# Town of Biltmore Forest

## Design Review Board

### April 2021 Projects for Review

Proposed 15'2" x 20' Deck

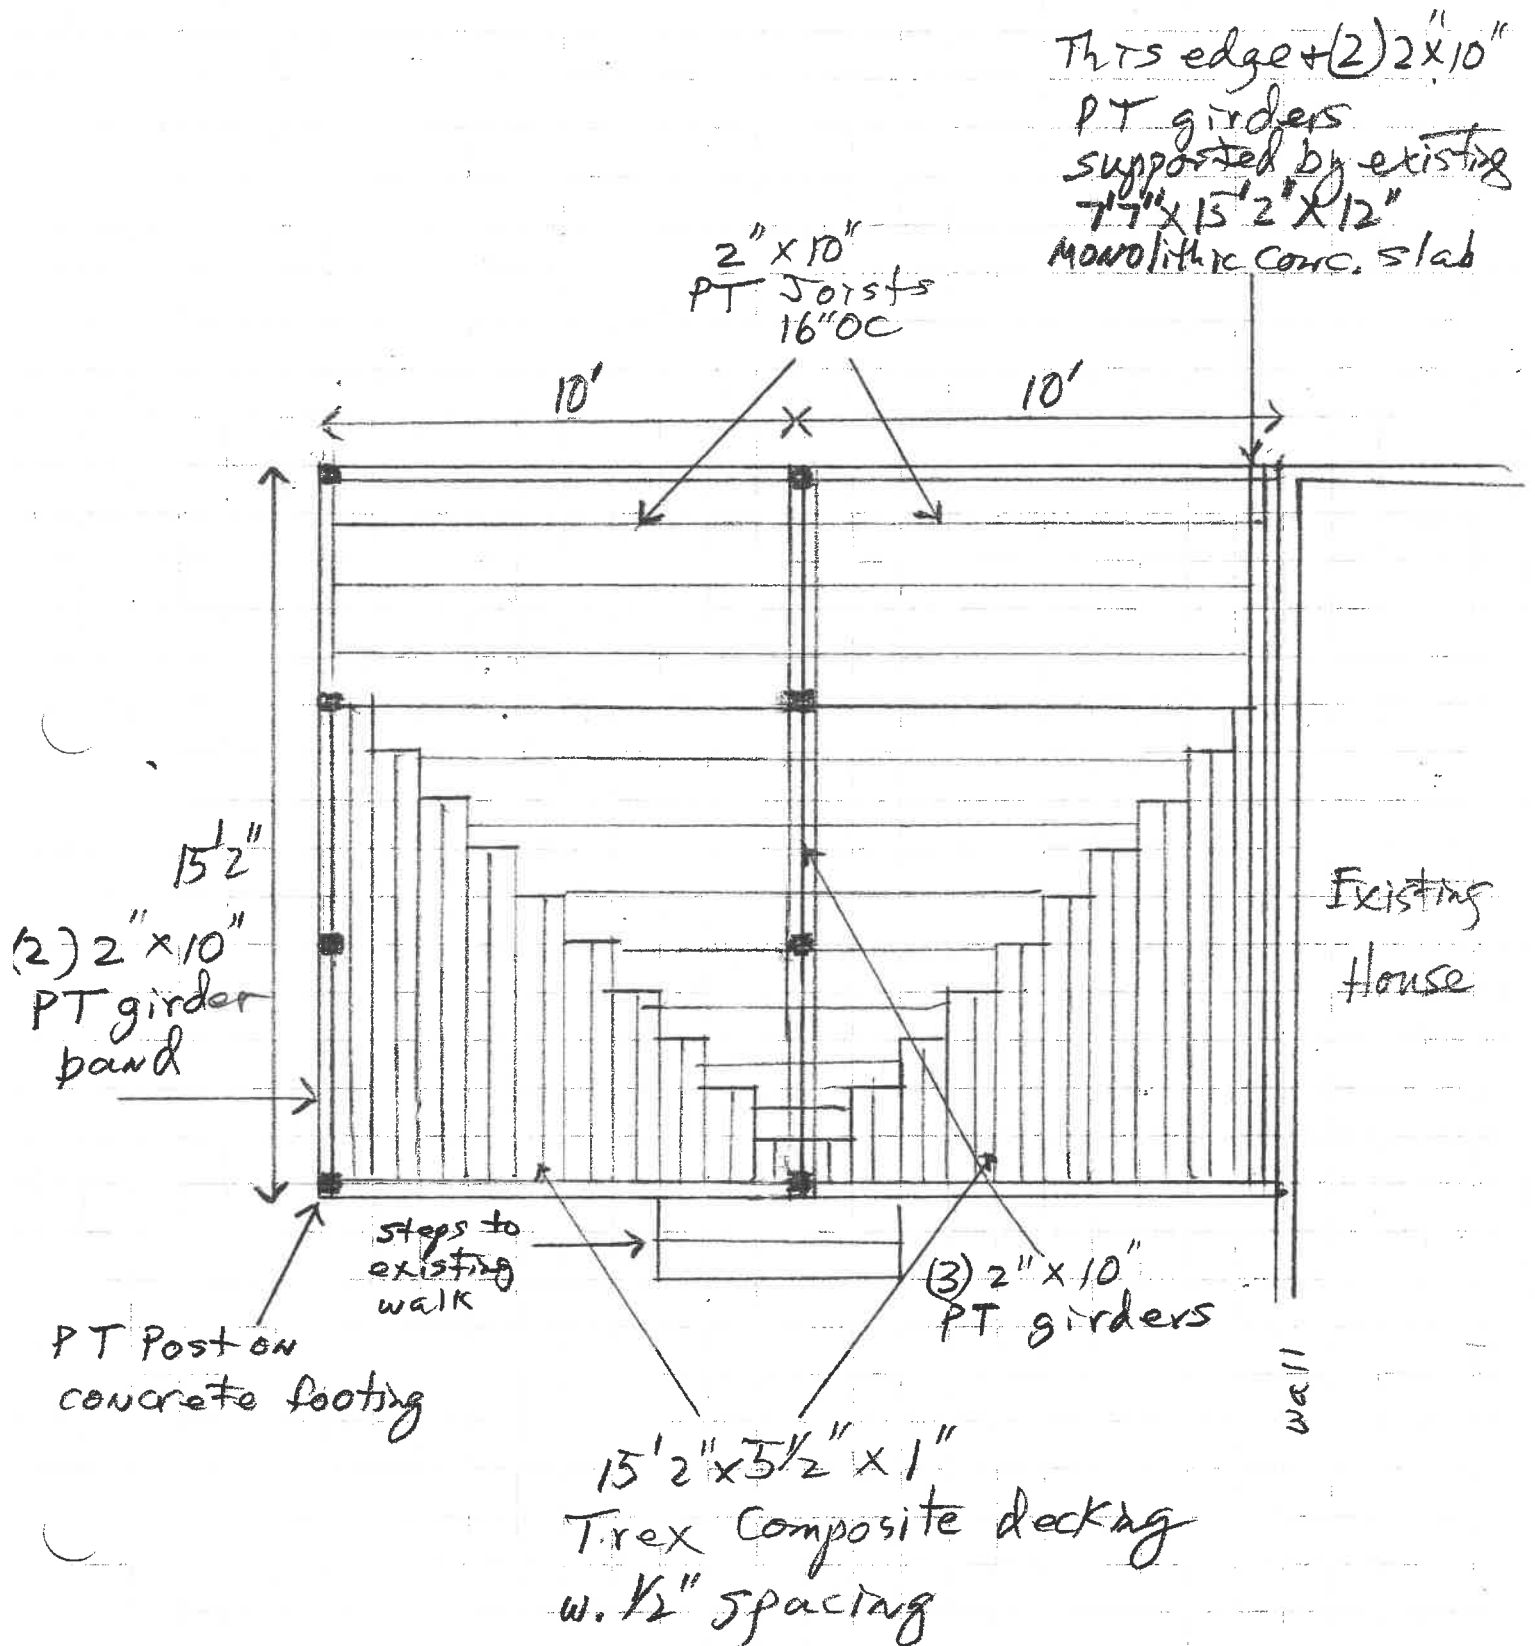
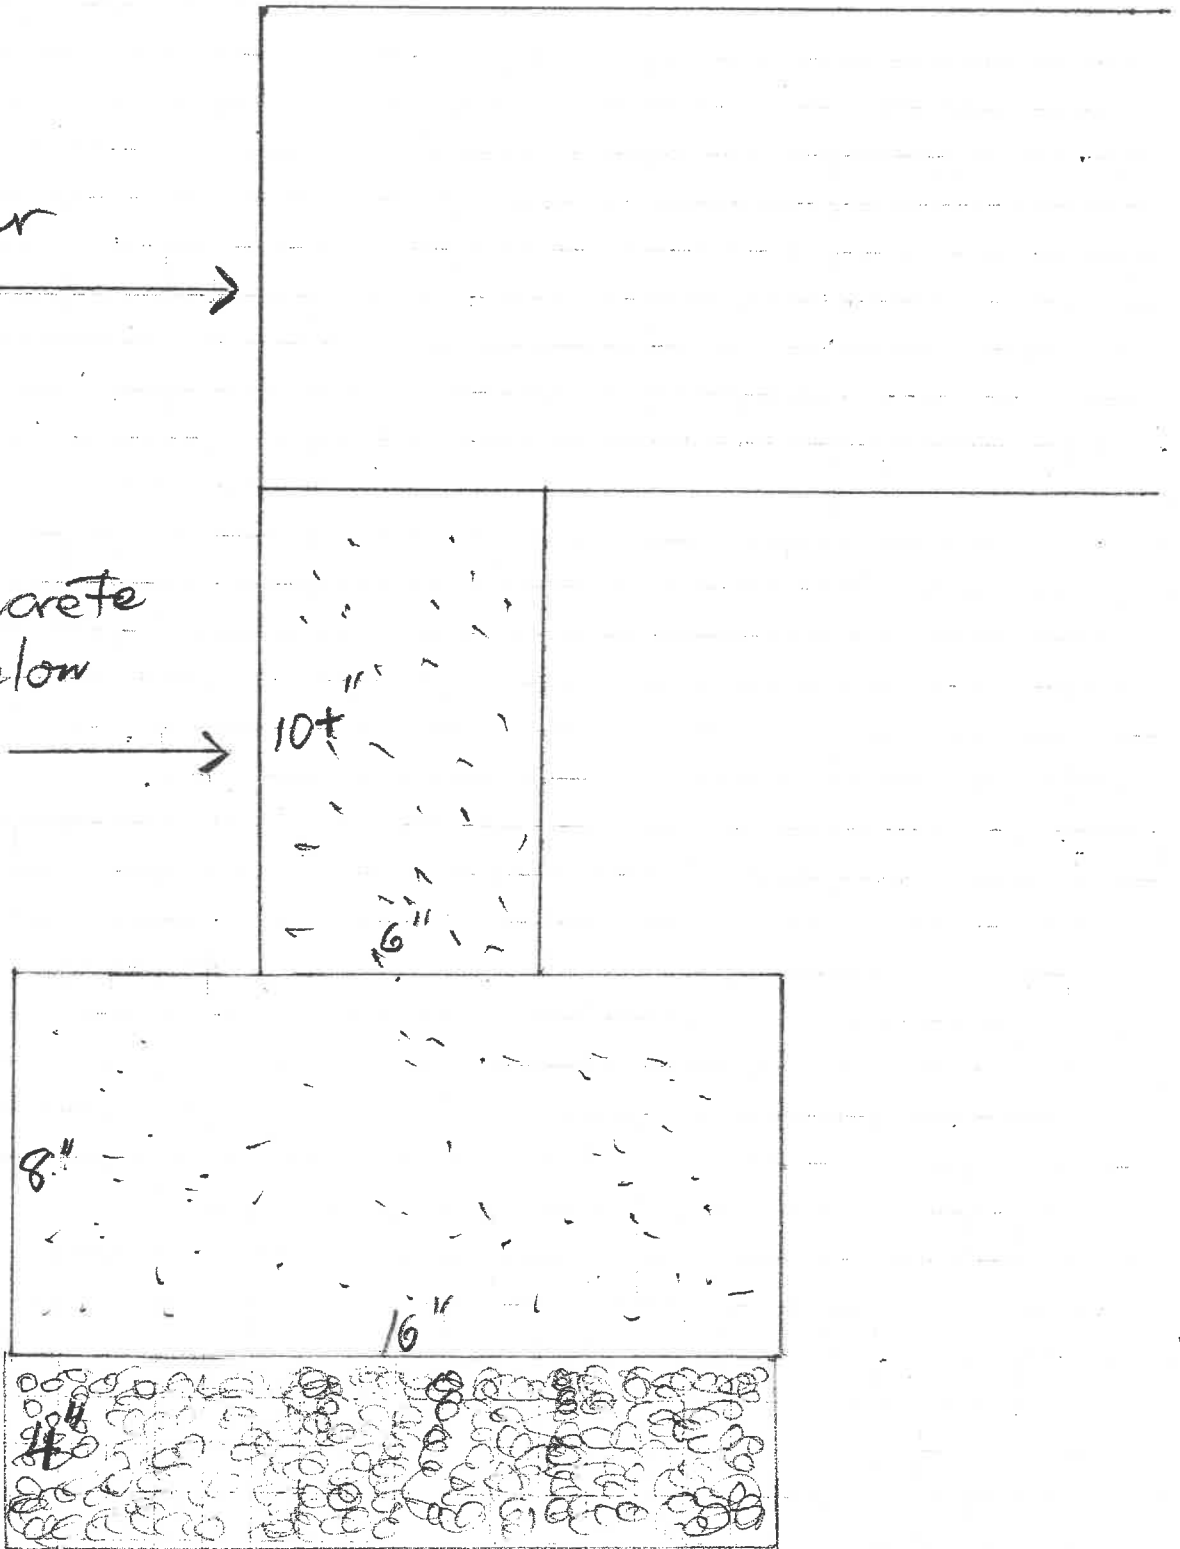
Jonathan,  
I have submitted my application on line & paid.  
I have one question about my proposed  
deck. On my drawing of the deck  
details, the southernmost <sup>center</sup> concrete  
support pier will be directly over my  
6" thick concrete walk to the existing  
concrete patio. Can I set the pier  
on the existing concrete walk or  
do I need to jack hammer the walk  
there and install a new concrete section  
etc. as needed for the other 7 pier  
locations? Please excuse my  
amateur drawings. Thank you for  
your help.  
(336) 210-9868

SITE PLAN

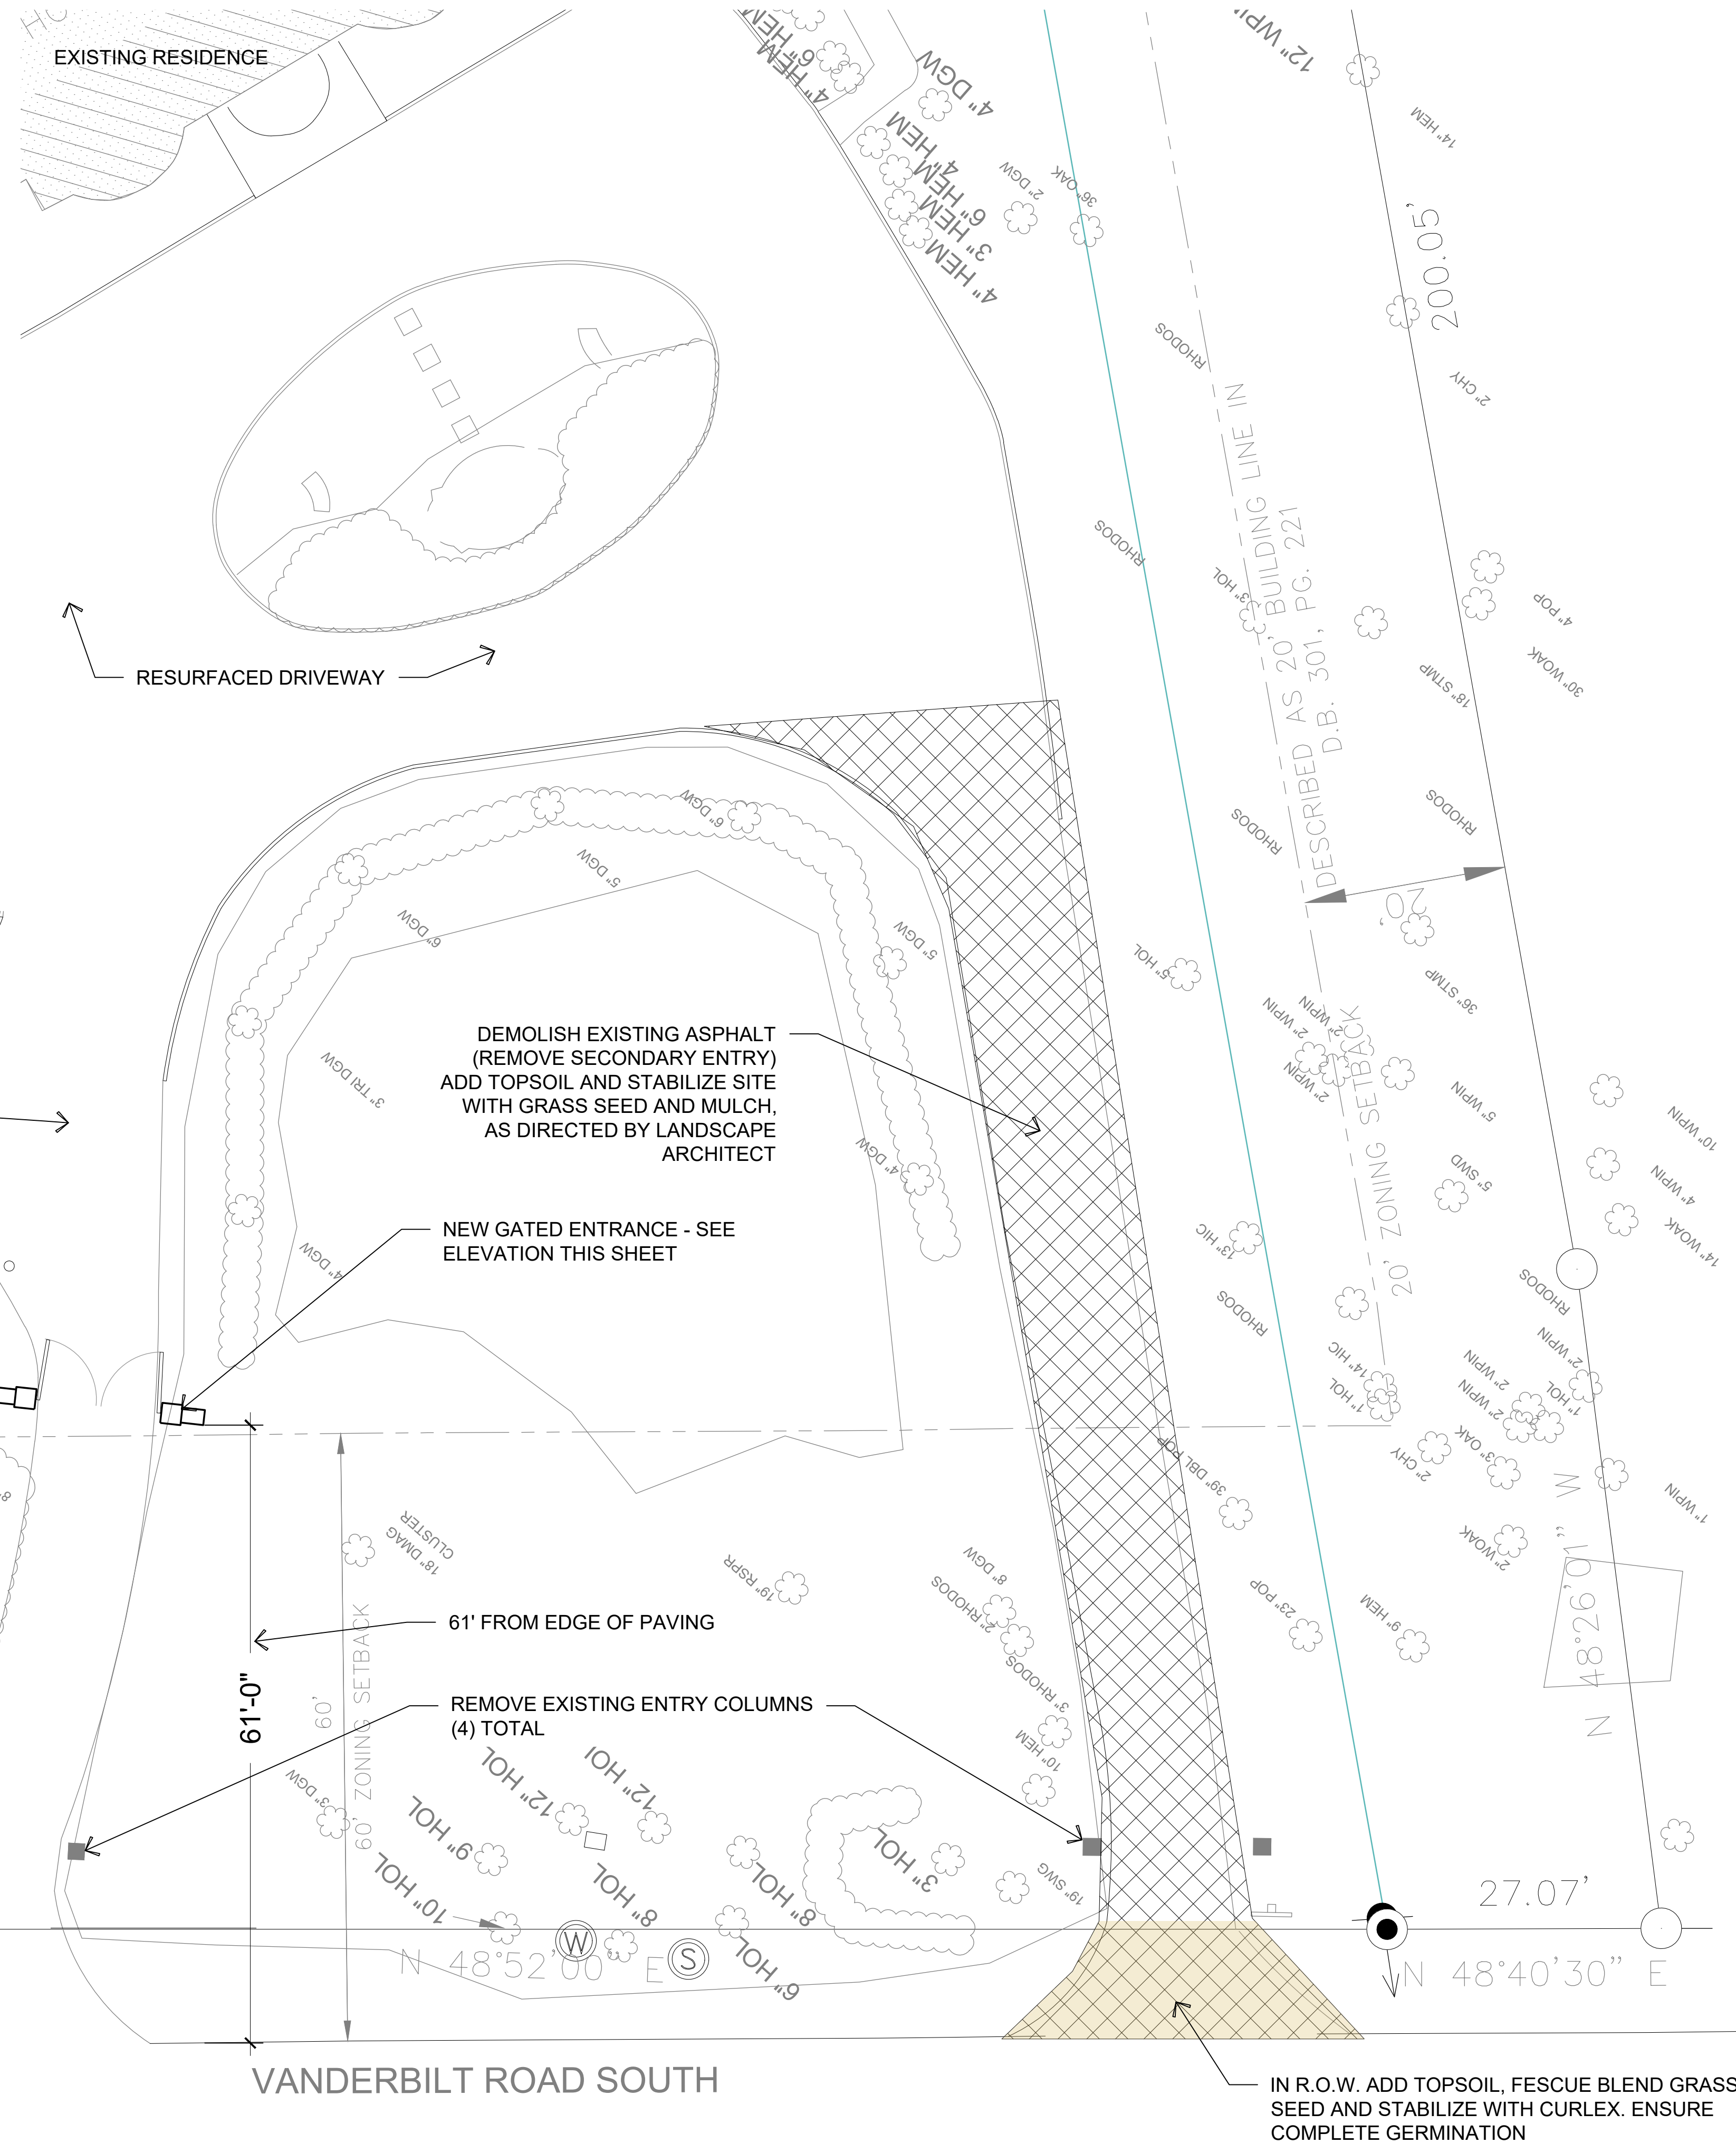
The initial proposal includes a gate opening of 12 feet. After reviewing the proposal, I contacted Skyland Fire Department and asked them to provide thoughts on this plan. Interim Chief Trevor Lance has indicated that a column width of 14 feet (particularly since the proposed gate/columns are farther onto the property than present) will be sufficient to provide access. Sitework Studios and the applicant are in agreement with this and are working on a revised plan showing the 14 foot wide entrance. This will allow full compliance with the Special Use requirements for this specific accessory structure within the Town's Zoning Ordinance.
